PACSystems™ RX3i

NON-ISOLATED ANALOGUE INPUT MODULES
WITH HART COMMUNICATION (IC695ALG626,
IC695ALG628)

NON-ISOLATED ANALOGUE INPUT MODULES
(IC695ALG608 & IC695ALG616)

Figure 3: Field Wiring - Differential Mode

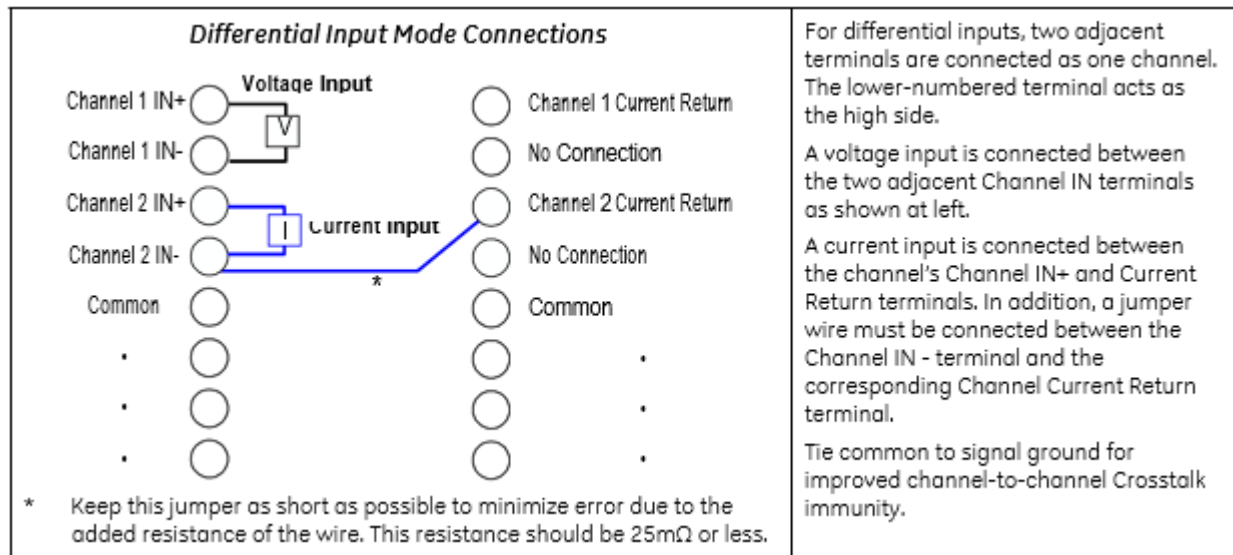
Module Version	Date	Firmware Revision	Description
IC695ALG626- KH (with HART) IC695ALG626CA- KH (with HART)	Dec 2022	2.13	Updates to address wiring connections for Non-Isolated Analog Input Modules configured for Differential mode.
IC695ALG626- KH (with HART) IC695ALG626CA- KH (with HART)	Dec 2022	2.13	This change addresses an issue where the ALG626 module could stop communicating, go lights out, or halt operation and enter a slow blink state on the Module OK LED when issuing a HART rediscover command. This change is only implemented on the IC695ALG626 module.
IC695ALG608CA-LG IC695ALG608-LG IC695ALG616-MG IC695ALG616CA-MG	Aug 2022	2.11	Product labels have been updated to show compliance with new certifications. For updated certifications, please refer to https://emerson-mas.force.com/communities/en_US/Article/Certifications-and-Agency-Approvals-Landing-Page
ALG608-KG ALG616-LG ALG626-KG ALG628-KG	Jul 2020	2.11	This change addresses component obsolescence with a new FW to support a drop-in replacement serial flash device. There are no changes to form, fit or function.

Terminal	8-Channel Modules	16-Channel Modules	8-Channel Modules	16-Channel Modules	Terminal
1	Channel 1 IN+		Channel 1 Current Return (IRTN1)		19
2	Channel 1 IN-		No Connection		20
3	Channel 2 IN+		Channel 2 Current Return (IRTN2)		21
4	Channel 2 IN-		No Connection		22
5	Common		Common		23
6	Channel 3 IN+		Channel 3 Current Return (IRTN3)		24
7	Channel 3 IN-		No Connection		25
8	Channel 4 IN+		Channel 4 Current Return (IRTN4)		26
9	Channel 4 IN-		No Connection		27
10	No Connection	Channel 5 IN+	No Connection	Channel 5 Current Return (IRTN5)	28
11	No Connection	Channel 5 IN-	No Connection		29
12	No Connection	Channel 6 IN+	No Connection	Channel 6 Current Return (IRTN6)	30
13	No Connection	Channel 6 IN-	No Connection	Channel 12 Current Return (IRTN12)	31
14	Common		Common		32
15	No Connection	Channel 7 IN+	No Connection	Channel 13 Current Return (IRTN7)	33
16	No Connection	Channel 7 IN-	No Connection		34
17	No Connection	Channel 8 IN+	No Connection	Channel 15 Current Return (IRTN8)	35

18	No Connection	Channel 8 IN-	No Connection		36
